Report on the status of work on the issue of electro-hydraulic systems, (ECE/TRANS/WP29/GRRF/2013/29)

Proposal:

Compatibility of the braking rate of the trailer and the mean fully developed deceleration of the tractor/trailer combination (trailer laden and unladen)

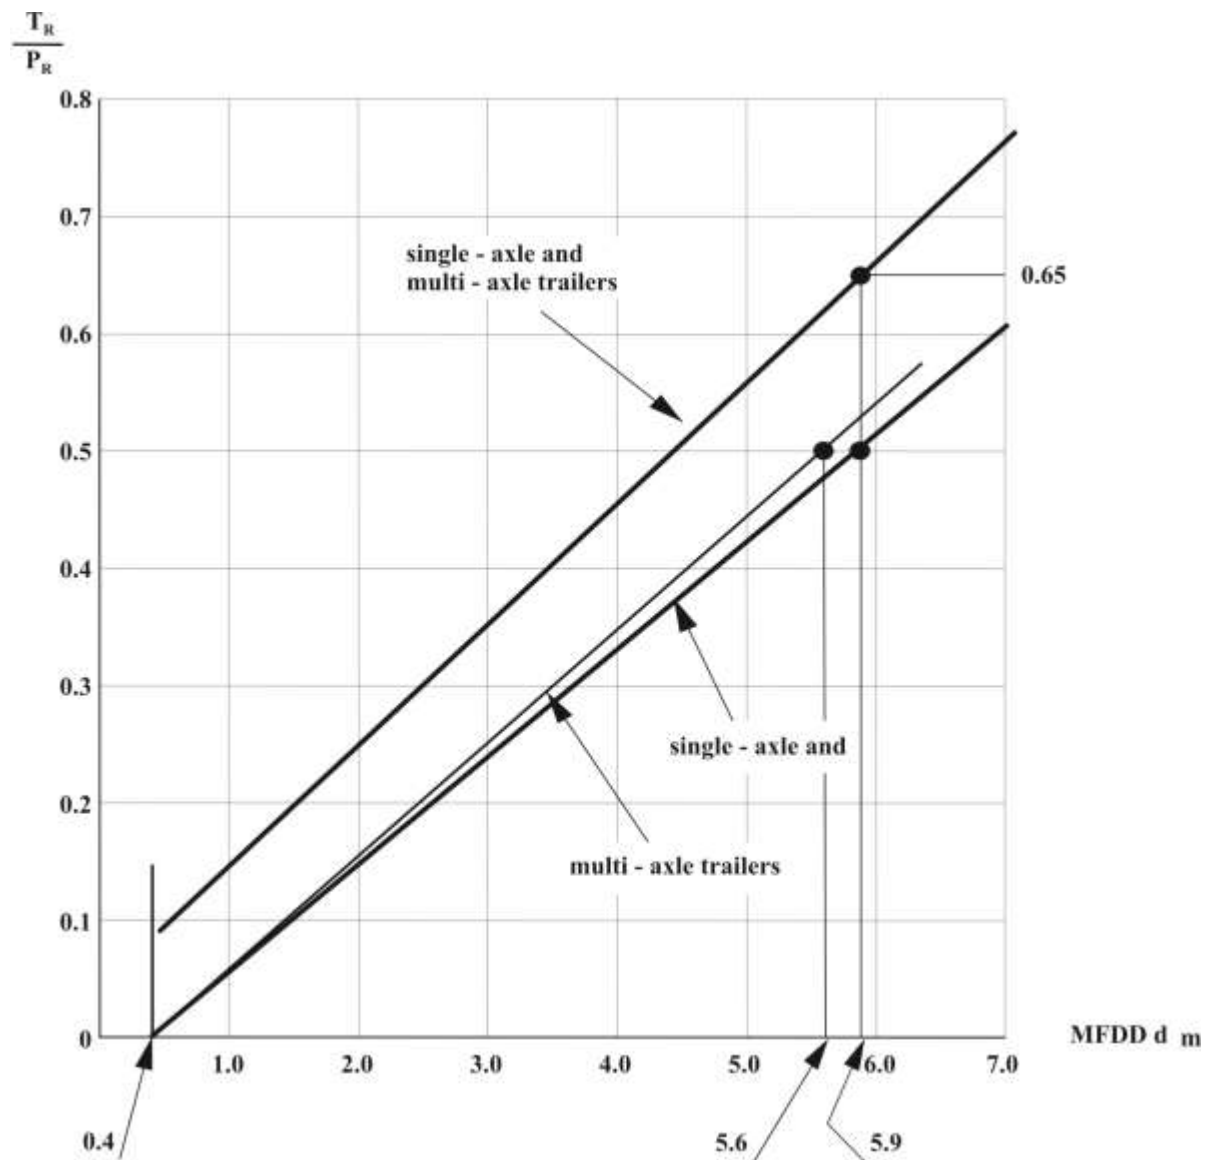
Annex 14, Appendix text in the diagram amend to read:

In the diagram the terms “centre-axle trailer” and “semi-trailer” shall be used instead of “single-axle trailer”. The term “full trailer” shall be used instead of “multi-axle trailer”

For clarification, in the past terms as multi axle trailer and single axle trailer were use. In the meantime these terms are replaced by full trailer, centre-axle trailer and semi-trailer.
